ADDENDUM 5

DATE: 05/25/22

'Matilda Torres High School, Toros Stadium'
Matilda Torres High School
16645 Road 26. Madera, CA 93638

DARDEN PROJECT NO. 0622.4
DSA File Nos. 10-C3
DSA APPL. NO. 02-118396

Q/S203

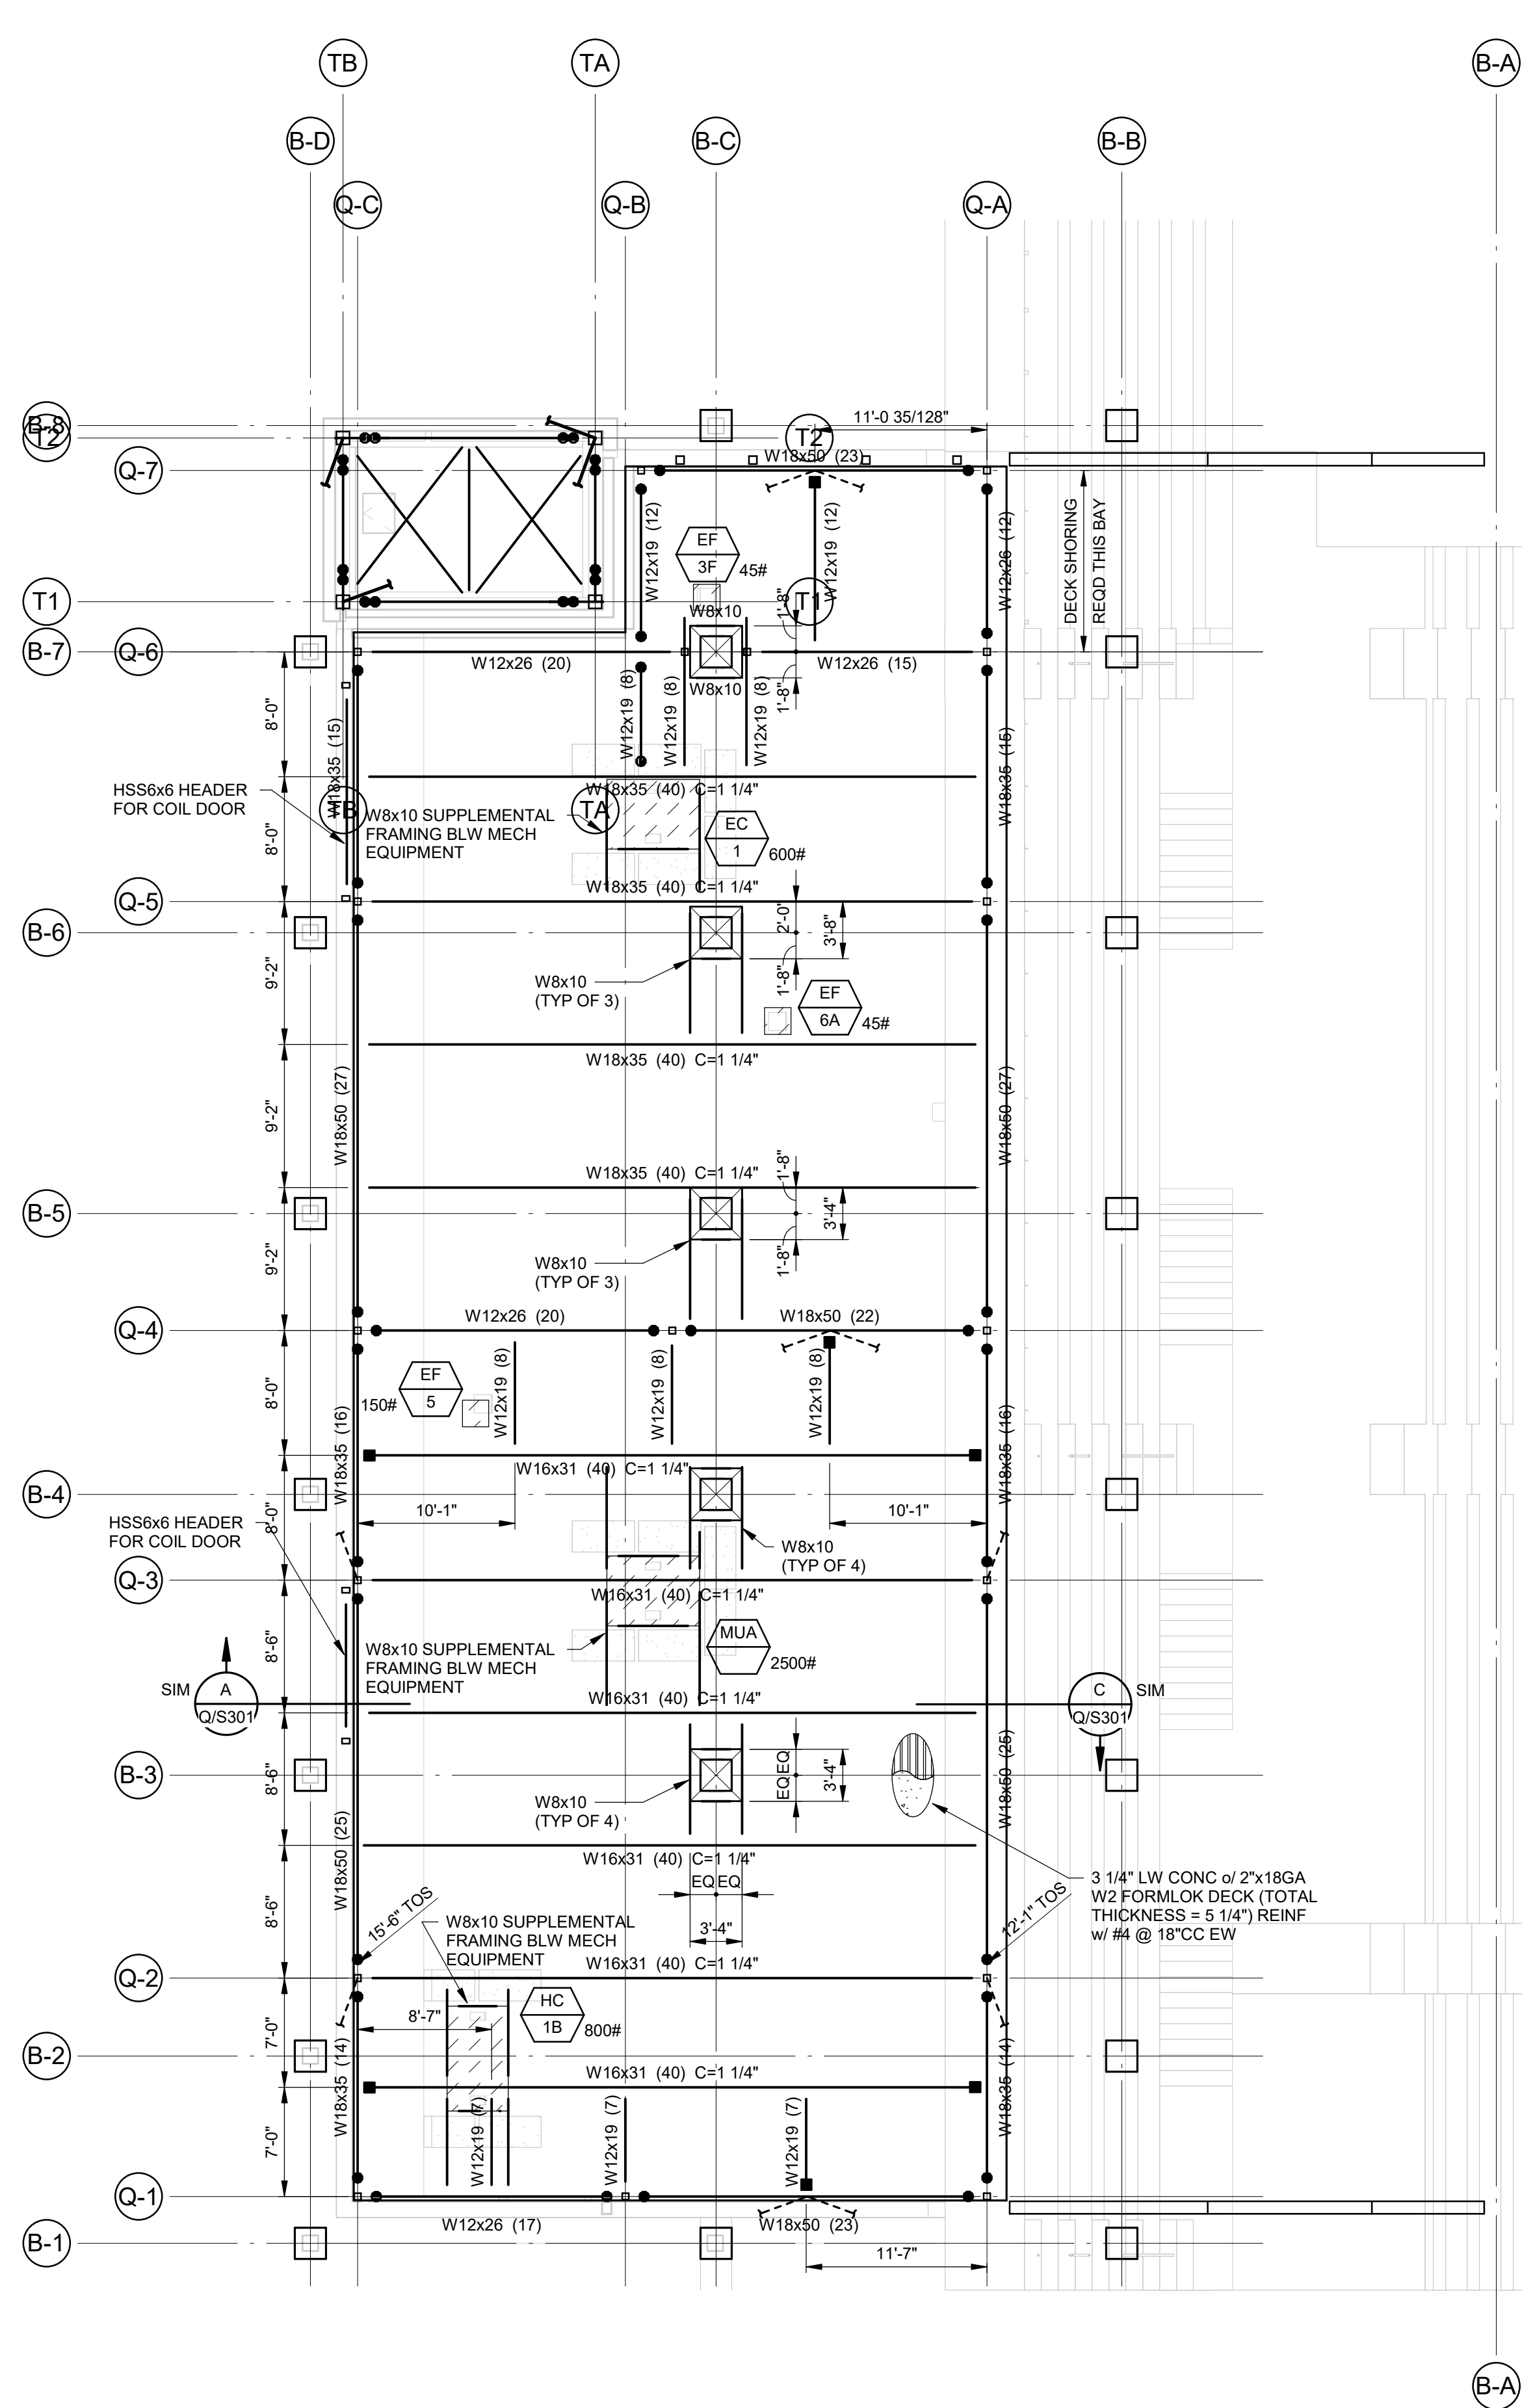
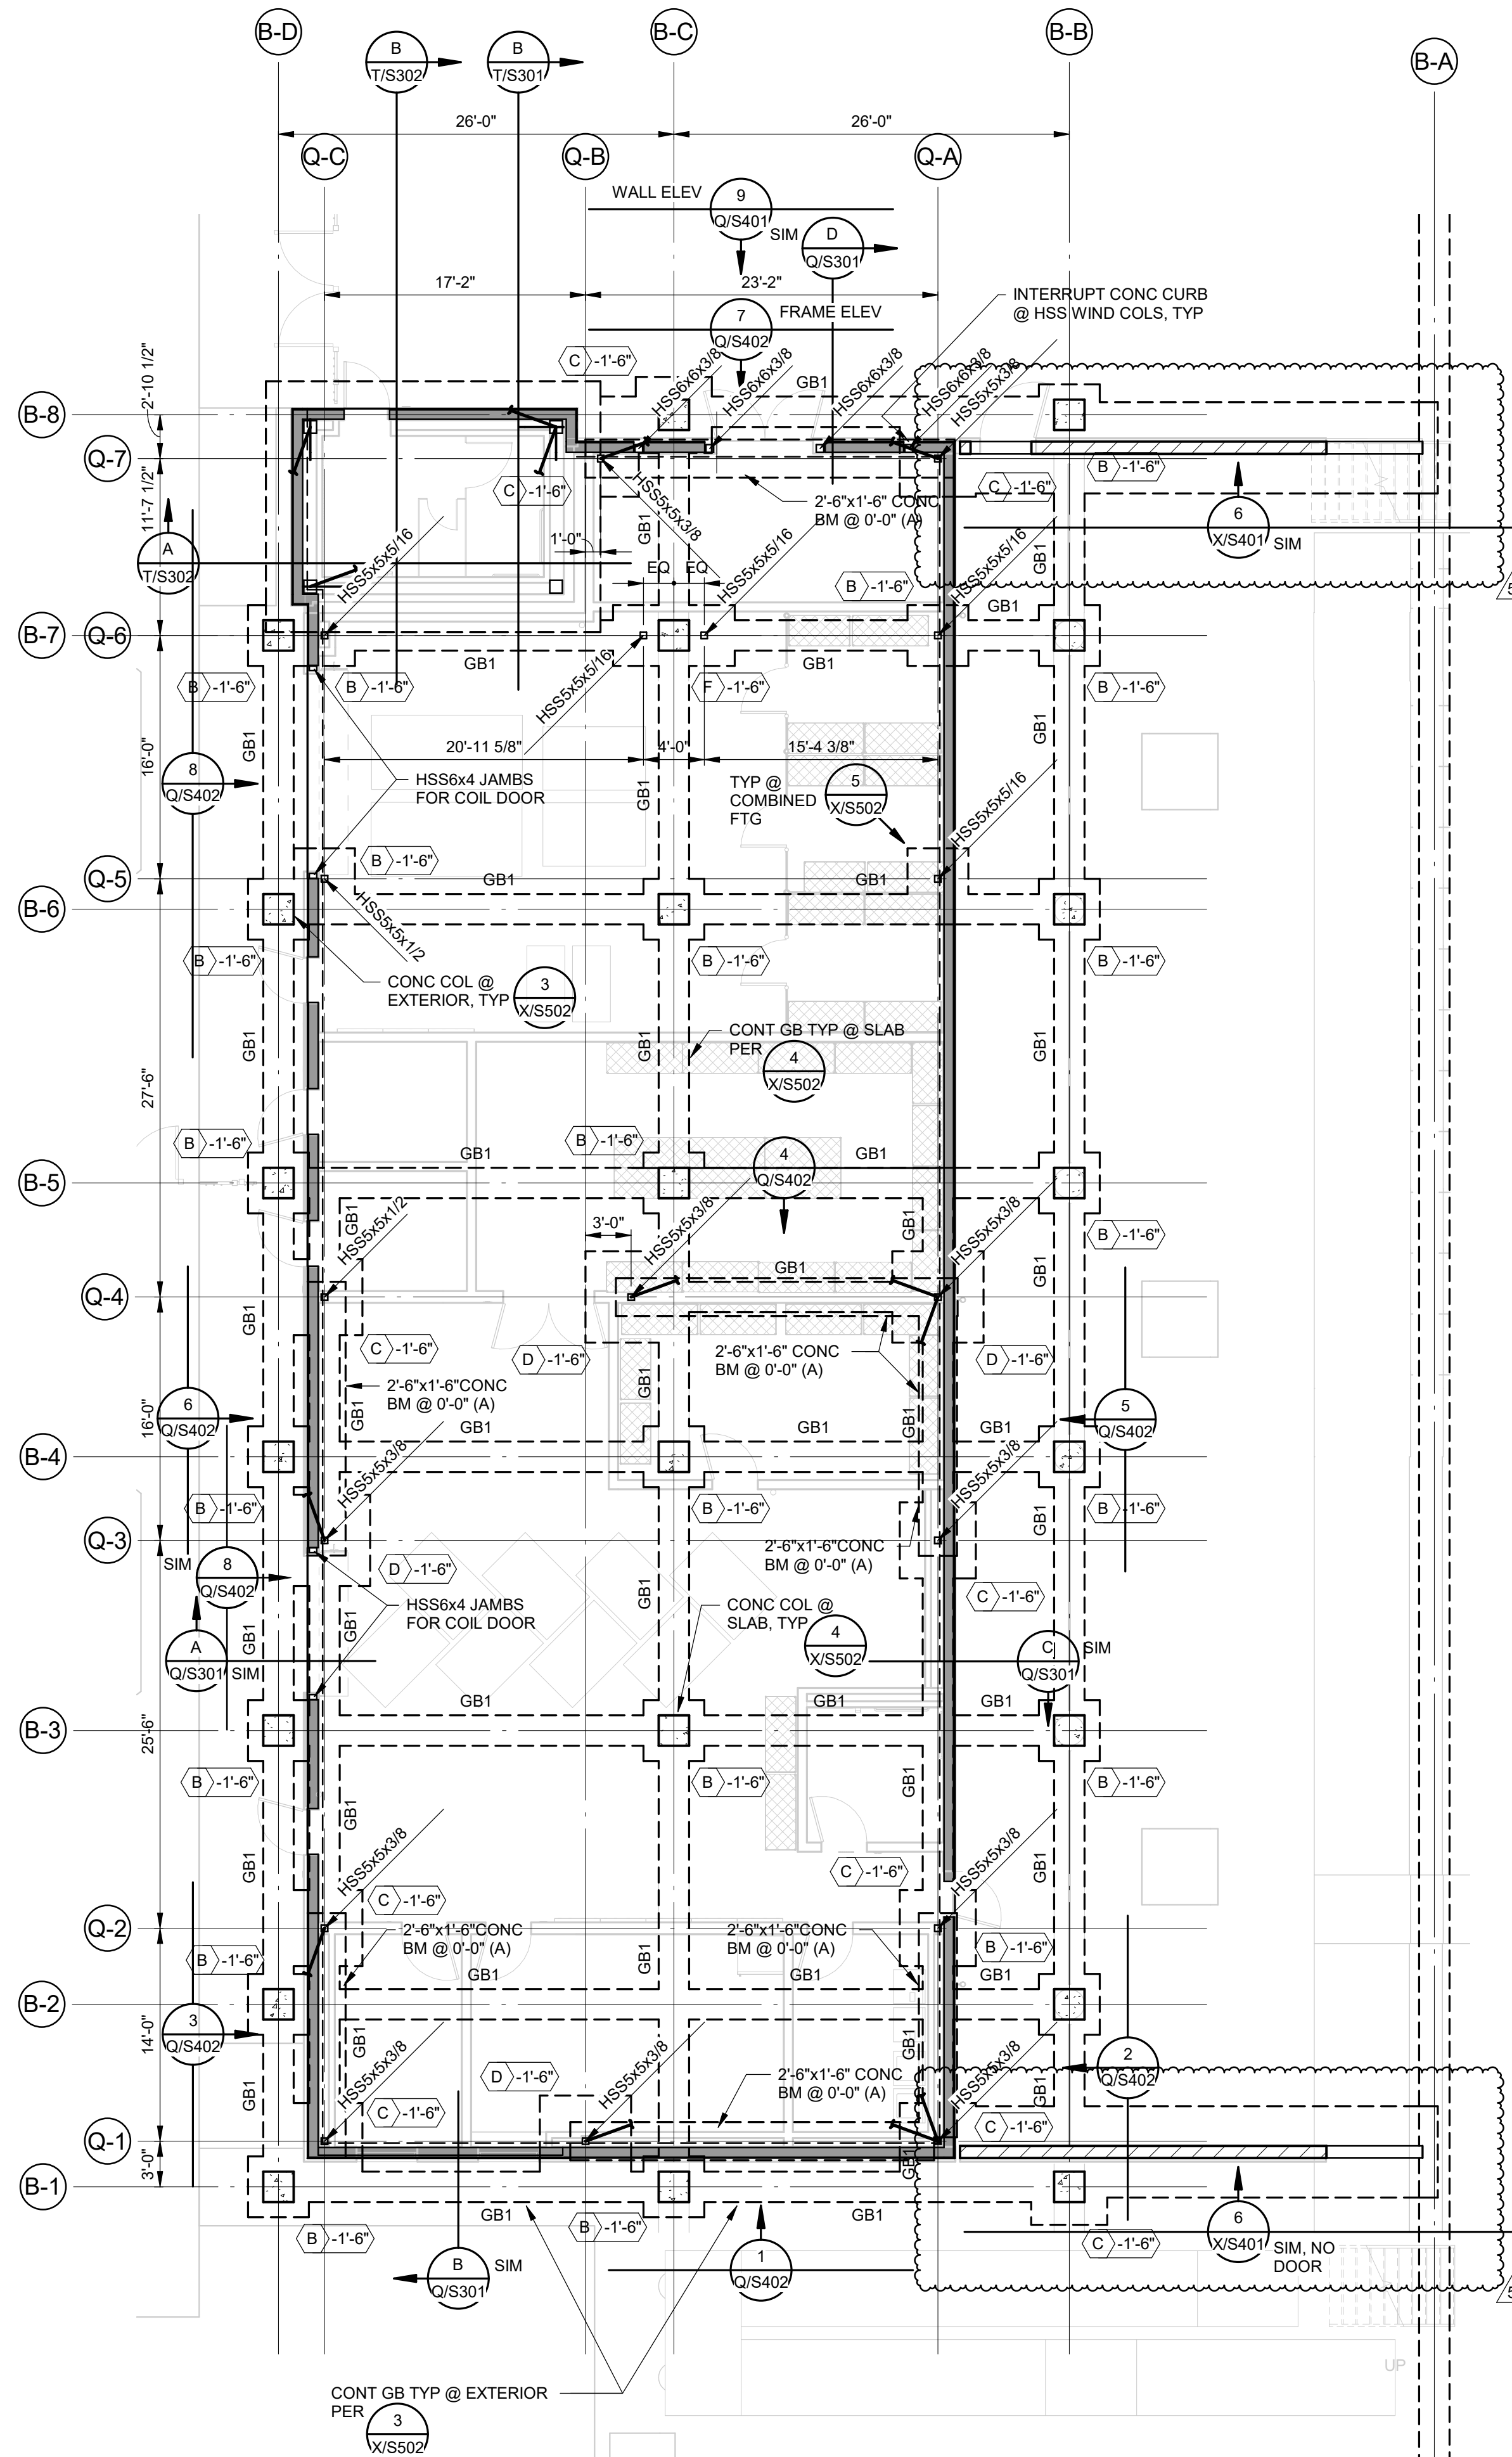
AD5-S03 Refer to Sheet Q/S203

1. Replace sheet with attached exhibit AD5-SX03
 - a. CMU wing walls and footings clarified.
